## Report to the Future Melbourne Committee

**Planning Permit Application: TP-2021-709**  
**620-632 Little Bourke Street, Melbourne**

**24 October 2023**

**Figure 11: Comparison of original and revised ground program illustrating deletion of porte-cochere access and increased activation to Little Bourke Street**

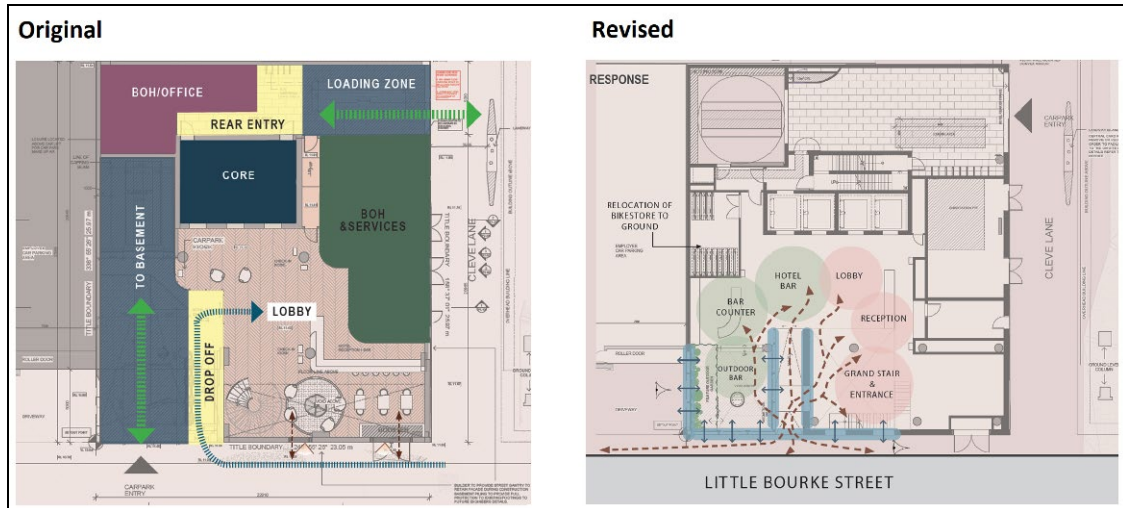
The advice from the MDRP provided a number of recommendations including to revisit the mass and scale of the building to be more sympathetic to the streetscape and heritage context, to reconsider the proposed vehicle access arrangement, refine the design narrative and detail, increase activation, human scale and improve the public realm response at the ground level.

- Deleting the ‘porte-cochere’ access and internal entry arrangement from Little Bourke Street, and consolidating vehicle access from the rear loading area from Cleve Lane.
- Increasing the extent of activation to Little Bourke Street by orienting the main building entry point directly to the street alongside an open bar / lounge area and entry lobby.

Figure 15: Streetscape setback plan illustrating increased setback to podium under Section 57A plans

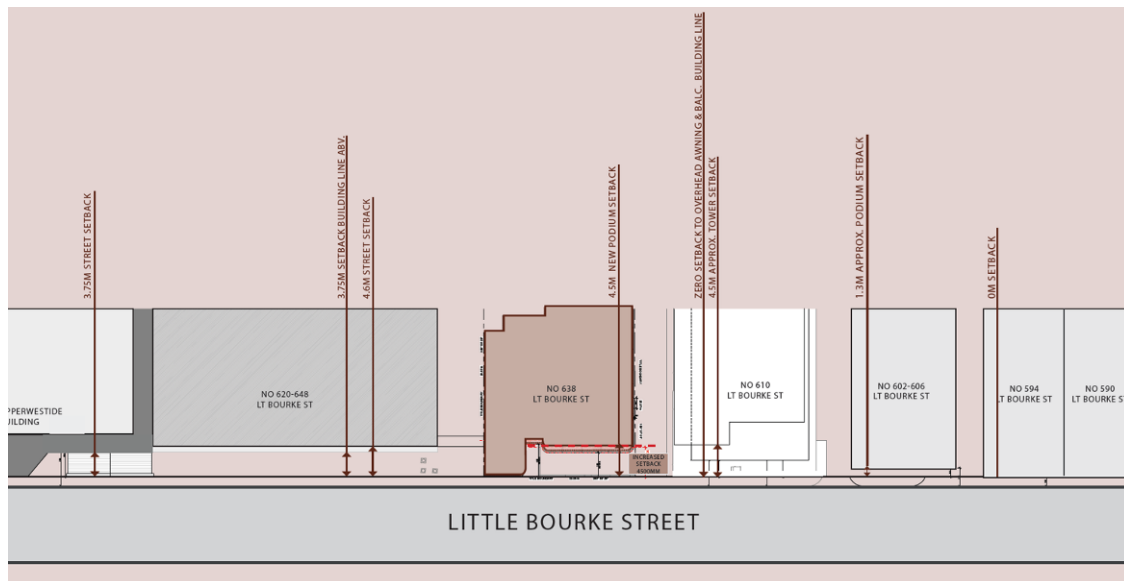
- An 800 mm increase to the podium setback above the retained heritage building, increasing from 3.7 to 4.5 metres.
- Provision of a 0.3 metre rebate setback at Level 2 of the proposed building along Cleve Lane

- *Provide an increased setback directly above the heritage substation. 4.5m minimum is recommended.*
- *Reduce the street wall height to a more contextual and appropriate height. A maximum height of 30m is recommended.*
- *Provide more active functions directly to the street.*
- *Further reflect the heritage attributes of the Substation building in the grain and materiality of the façade design, particular at the street wall level.*
- *Ensure any new windows and openings to the heritage building are of an exceptionally high quality, and respectful of the original design.*
- *Extend the proposed design concept 'in the round' to the western elevation. A blank surface with a painted mural or pattern will not be supported.*
- *Provide detailed material specification, selecting robust, textured and high quality materials appropriate and complementary to the heritage context.*

Figure 16: Southern elevation comparison illustrating reduced street wall height under Section 57A plans

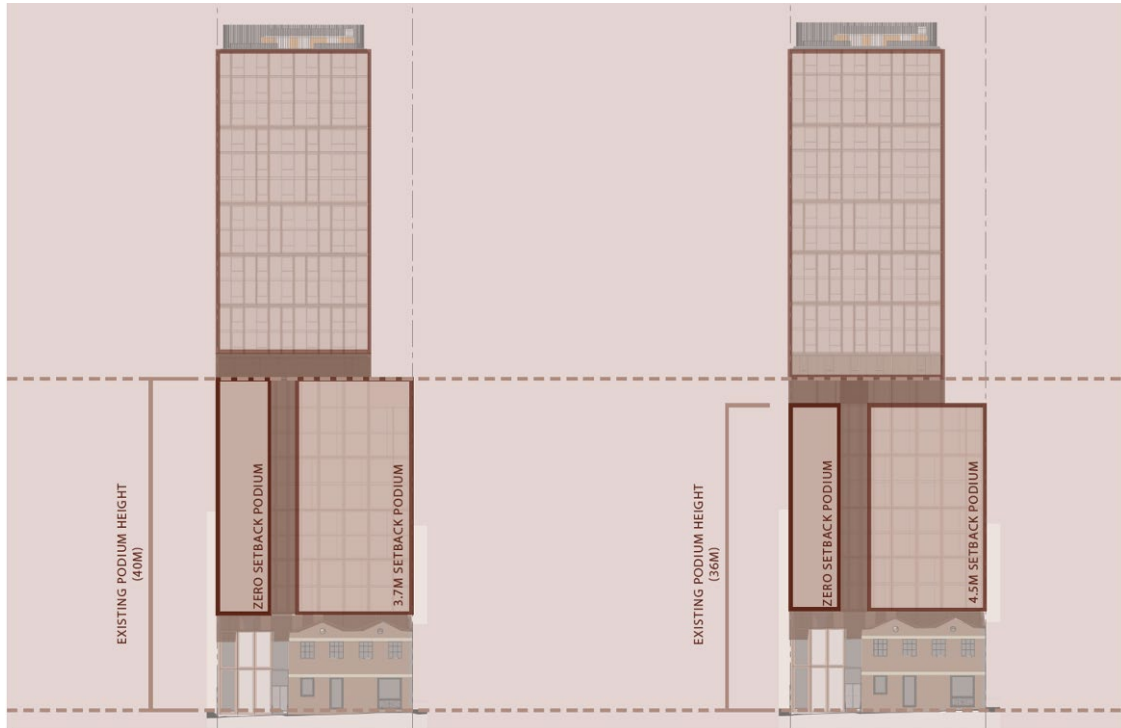
- A reduction to the height of the street wall from 40 metres to 36 metres.
- As a result of the above, a reduction to the total number of rooms from 212 to 207.
- Introduction of operable glazing around the ancillary bar area facing the street.

**Figure 19: Streetscape elevation illustrating proposed massing response to retained heritage building and neighbouring forms**

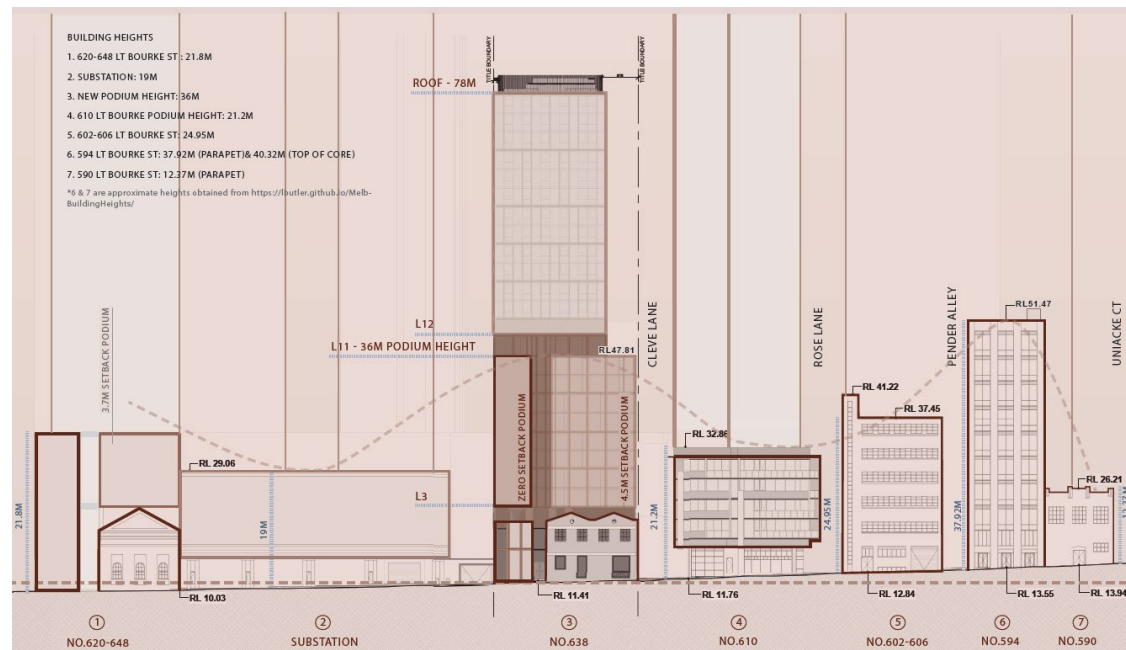
The amended design provides a 4.5 metre setback from the front wall of the retained building to the new podium form above, which references the length of a full internal structural bay or room. This setback is considered to achieve a meaningful level of physical recession as read from key vantage points along Little Bourke Street, and will appropriately demarcate the retained significant building within the streetscape.

Importantly, the proposal no longer includes any cantilevered or projecting built form within the air space directly above the retained principal part of the building.

**Figure 20: Isometric elevation of retained built form showing proposed external alterations**

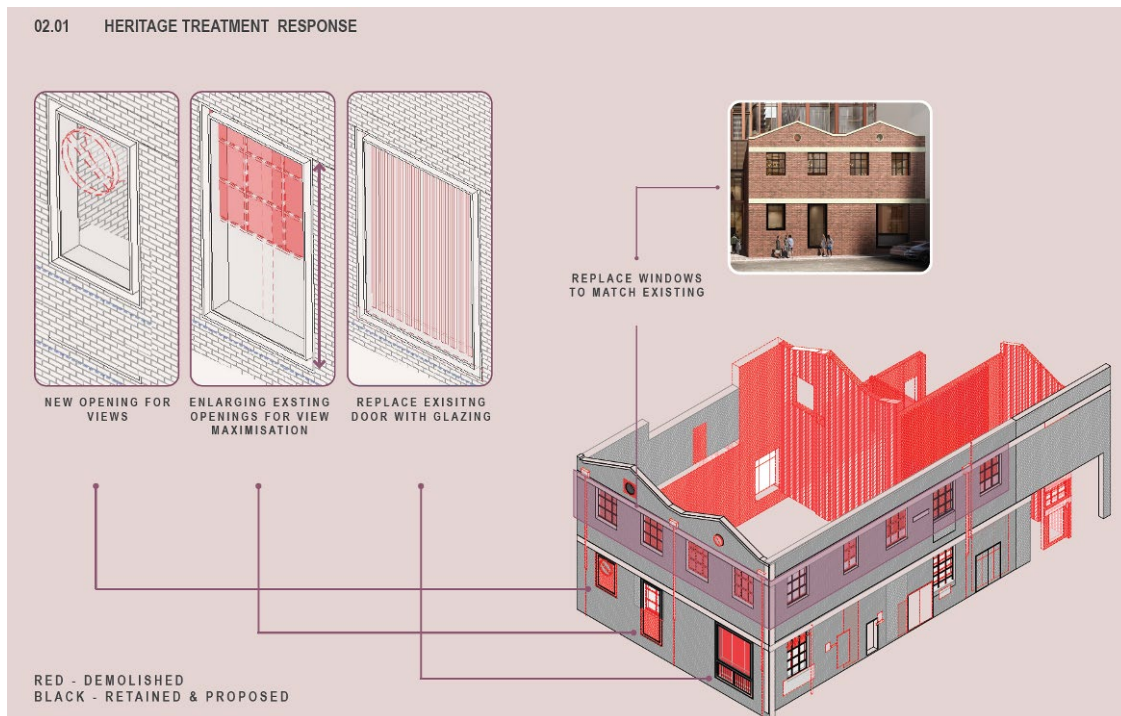
The modified and refurbished openings around the retained structure, seek to maintain existing proportions in terms of their location, width and separation.

The introduction of new windows has been undertaken in a generally sympathetic nature and will enable an improved level of activation and balances the conservation of the building with the capital city function of the surrounding context.
